| Intersection ID: 50301 | Main Street: WINGED_TEAL_RD | Cross Street: PINE_CHAPEL_DR | Location: | NW |
| ADA ID: 3733595AE2A6 | Ramp Type: PerpDiag | Initial Pass/Fail: Fail | Overall Compliance: No | Severity Score: 21.25 |

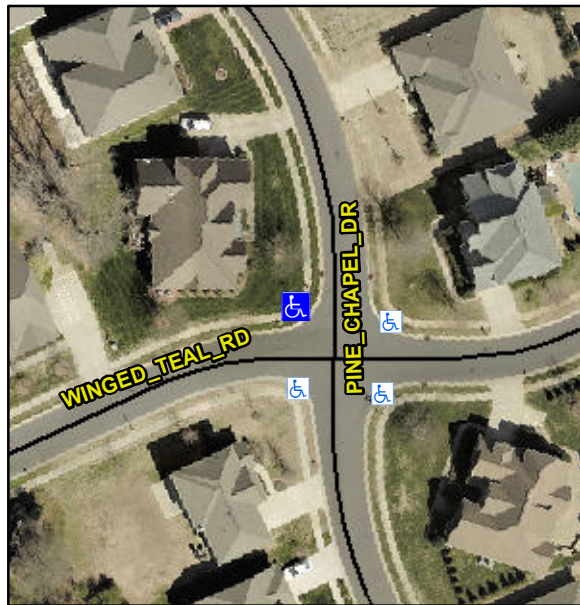
R304.5.1, R304.2.2

| Compliance | Description | Data | Compliance | Description | Data |
|------------|-----------------------|------|------------|-----------------------------|------|
| N/A | Ramp Length (in) | 48.0 | No | Ramp Slope (%) | 8.9 |
| No | Ramp Width (in) | 46.5 | Yes | Ramp XSlope (%) | 1.4 |

Remove & Replace Curb Ramp With Two New Directional Ramps or Equivalent.
